DOCKETS 50-266 AND 50-301
SUPPLEMENT 5 TO APPLICATION FOR AMENDMENT TO
FACILITY OPERATING LICENSE APPENDIX A:
TECHNICAL SPECIFICATIONS IMPROVEMENT PROJECT
RESPONSE TO RAI ON ITS SECTIONS 3.4 and 3.9
POINT BEACH NUCLEAR PLANT, UNITS 1 AND 2

Attachment 1 – NMC RAI Response to ITS Sections 3.4 and 3.9

RESPONSE TO REQUEST FOR ADDITIONAL INFORMATION

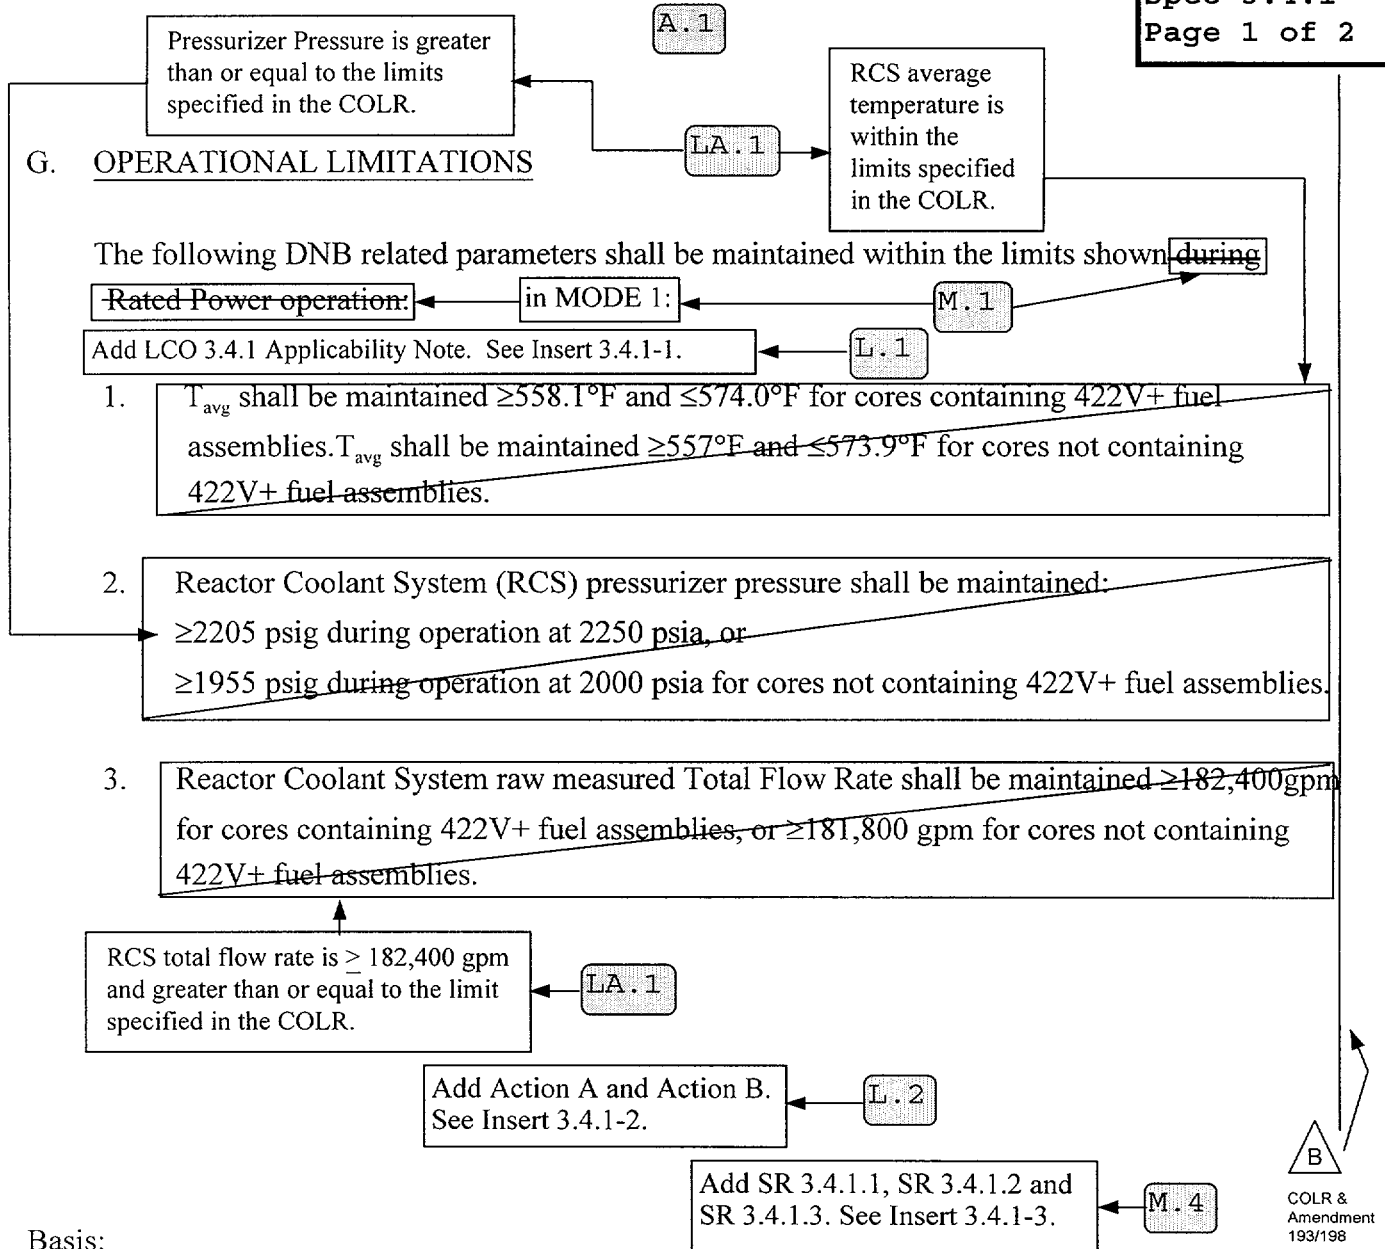
Comment: There is not a discussion in the Bases concerning when either of these limits apply, and whether the limits change linearly between these pressures. Provide an explanation.

Proposed ITS section 3.4.1 has been completely revised based on incorporation of the Core Operating Limits Report (COLR), TSTF-339, and Amendments 193/198, approved 2/08/00 (related to incorporation of new fuel design at PBNP). The pressurizer pressure limits and their explanation are now included in the COLR, and are dependent on the type of fuel design used in the reactors (i.e. the upper limit is to be used when there is 422V+ fuel in the reactor). The COLR was submitted to the NRC as TSCR 218, dated 03/02/2000.

As a result of incorporating these submittals, DOC M.02 was changed to "not used" and new DOC LA.01 was created (since this change is now less restrictive), a new "LA" NSHC was created, JFD 01 and JFD 02 were slightly revised, the CTS markup, the NUREG markup, and the proposed ITS and associated Bases were revised as appropriate (see attached markups).

RAI 3.4.7-3

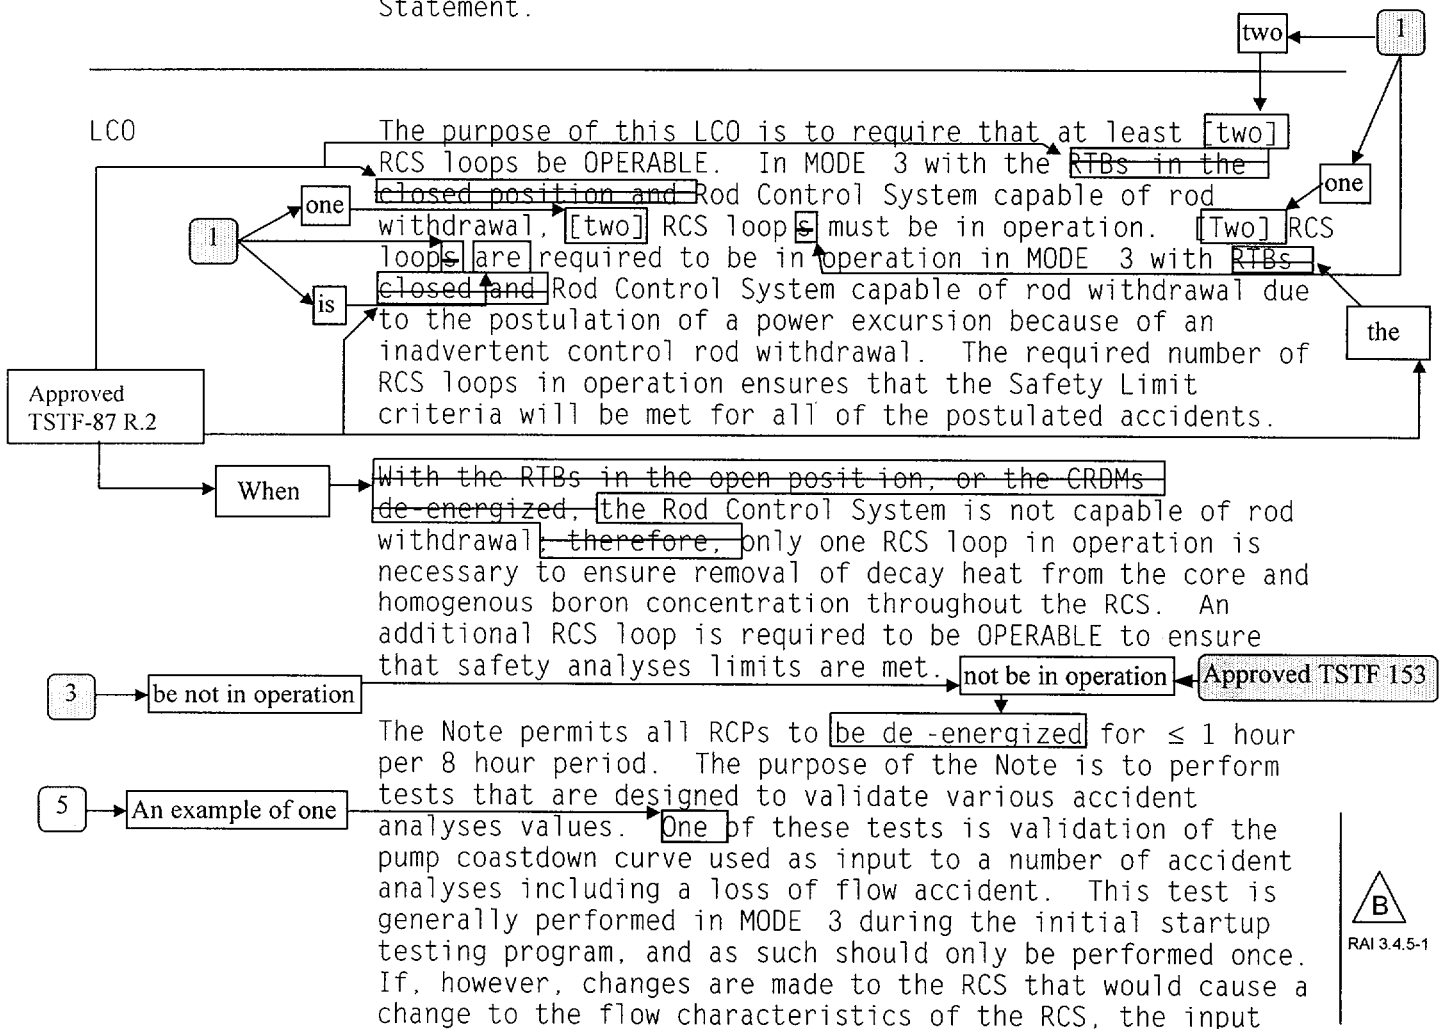
Comment: Recommend also adding “narrow range” to ITS SR 3.4.5.2 and ITS SR 3.4.6.2. Request you submit a TSTF change proposal to modify the STS.

ITS SR 3.4.5.2 and ITS SR 3.4.6.2 have been modified to specify that steam generator level must be $\geq 30\%$ narrow range. Appropriate justifications for these changes have also been provided.

Insert B3.9.3-1:

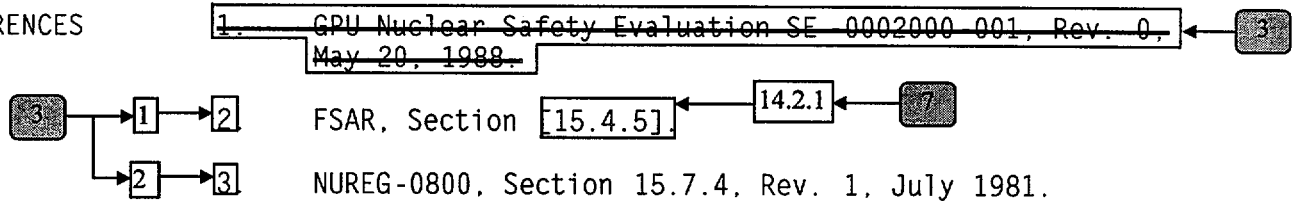
Comment: The middle paragraph of DOC L.3 seems to be a very appropriate paragraph to include in the Bases, on why it is acceptable for both airlock doors to be open during fuel movement and other core alts.

ITS 3.9.3 Bases, LCO Section, has been modified by the addition of a statement that provides the basis for allowing containment personnel airlocks to remain open during fuel movements and core alterations.

The containment personnel airlock doors may be open during movement of irradiated fuel in the containment and during CORE ALTERATIONS provided that one door is capable of being closed in the event of a fuel handling accident. Should a fuel handling accident occur inside containment, one personnel airlock door will be closed following an evacuation of containment.
